APPEAL SUMMARY

Appeal ID: 18772	Project Address: 3714 SW Macadam Ave
Hearing Date: 12/19/18	Appellant Name: Jeancarlo Saenz
Case No.: B-007	Appellant Phone: 9727269400
Appeal Type: Building	Plans Examiner/Inspector: Maureen McCafferty, Joe Thornton
Project Type: commercial	Stories: 8 Occupancy: R-2, M, S-2, A-3 Construction Type: Type I-A & Type III-A
Building/Business Name: E2 - Block 40	Fire Sprinklers: Yes - Thoroughout
Appeal Involves: Erection of a new structure	LUR or Permit Application No.: 17-110666-LU
Plan Submitted Option: pdf [File 1] [File 2]	Proposed use: Mix-use building

APPEAL DECISION

FLOOR PLAN GARAGE LEVEL 2

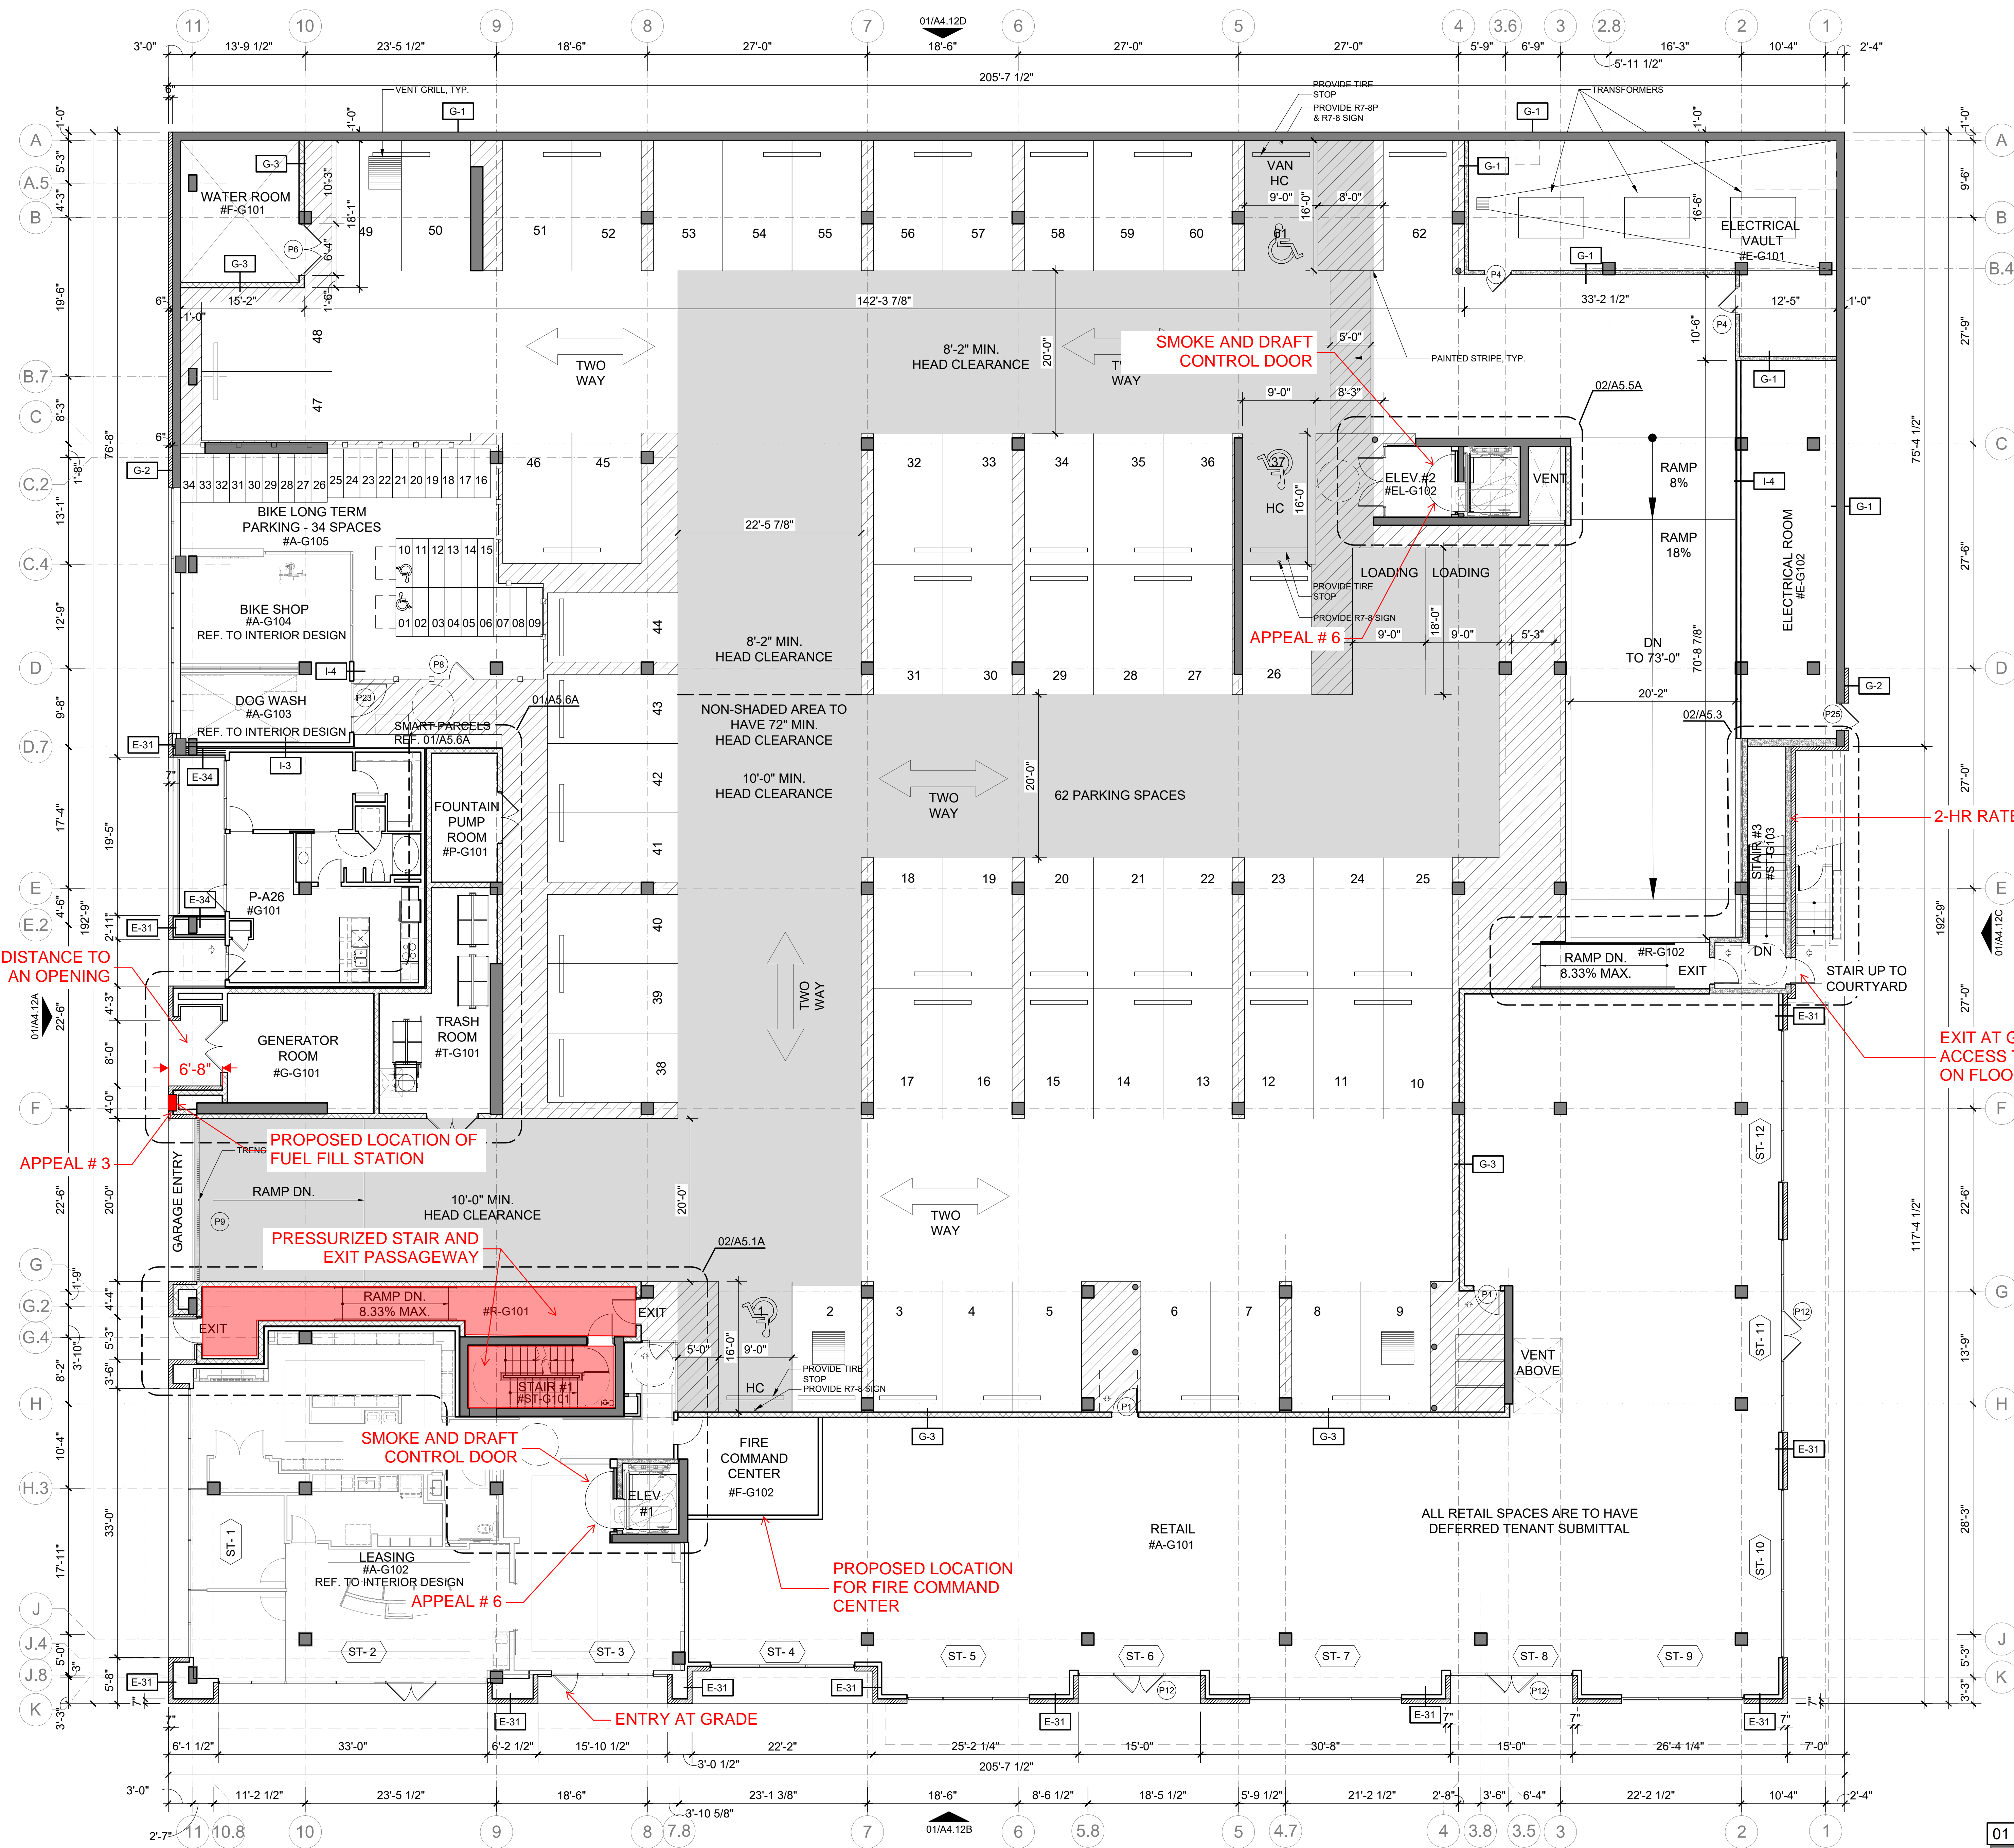
Proposed Design The proposed design is an 8-story mixed-use high-rise multi-family building, with 5 levels of Type III-A construction over 3 level of Type I-A construction at grade. There is 1 level of below-grade parking, also of Type I-A construction. The building will be equipped throughout with an automatic sprinkler system. The fire pump room is located at Garage level 2, at the northwest corner of the parking garage.

The fire pump room enclosure is 3-hour rated, and the nearest exit stair enclosure is 2-hour rated. The path of travel between the fire pump room and the enclosed exit stairway measures 18 feet in length and is sprinklered per NFPA 13. The path is unenclosed and is along a corridor in the garage that is isolated from car traffic.

3. Omission of 2 hour fire rated passageway connecting fire pump room to exit: Granted as proposed.
